SEMINOLE COUNTY GOVERNMENT
1101 EAST FIRST STREET, 2ND FLOOR, WEST WING
SANFORD, FLORIDA 32771

PROJECT NAME:	PRESSVIEW AVE - PRE-APPLICATION	PROJ #: 23-80000168
APPLICATION FOR:	DR - PRE-APPLICATION DRC	
APPLICATION DATE:	2/28/24	
RELATED NAMES:	EP BRENDA PEARCE	
PROJECT MANAGER:	KATHY HAMMEL (407) 665-7389	
PARCEL ID NO.:	01-21-29-5CK-170H-0010	
PROJECT DESCRIPTION	PROPOSED SITE PLAN FOR A NEW WATER METER SYSTEM INSTALLATION ON 0.50 ACRES IN THE R-1A ZONING DISTRICT LOCATED ON THE SOUTHWEST CORNER OF SR 434 AND PRESSVIEW AVE	
NO OF ACRES	0.50	
BCC DISTRICT	3-Lee Constantine	
CURRENT ZONING	R-1A	
LOCATION	ON THE SOUTHWEST CORNER OF SR 434 AND PRESSVIEW AVE	
FUTURE LAND USE-	LDR	
SEWER UTILITY	SUNSHINE WATER SERVICES	
WATER UTILITY	SUNSHINE WATER SERVICES	
APPLICANT:	CONSULTANT:	
BRENDA PEARCE BLACK & VEATCH/SUNSHINE WATER 200 WEATHERSFIELD AVE ALTAMONTE SPRINGS FL 32714 (678) 656-5179 PEARCEB@BV.COM	N/A

PROJECT AREA ZONING AND AERIAL MAPS

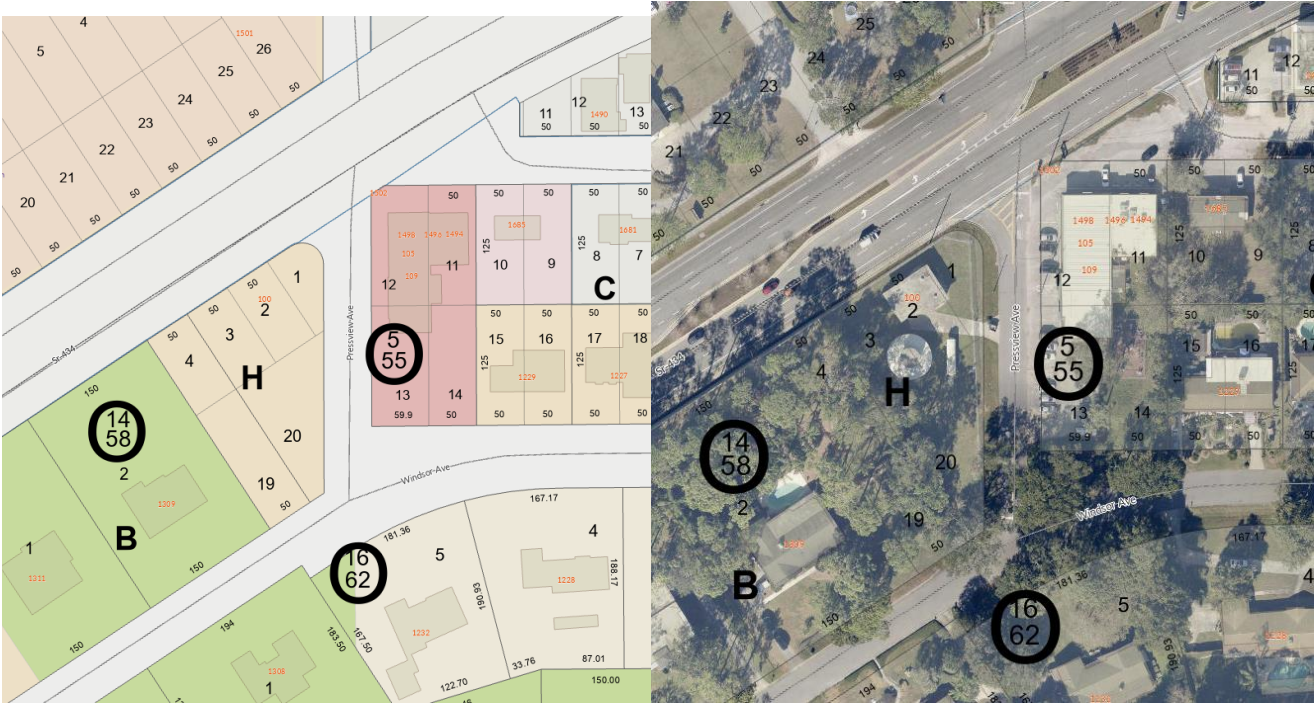
The parcel is located within unincorporated Seminole County and has a zoning classification of R-1A (Single Family Residential).

The installation of a pole with an antenna for a new water metering system will require a Special Exception to allow the use in the applicable zoning district. A variance to the building/structure height of 35 feet may also be required.
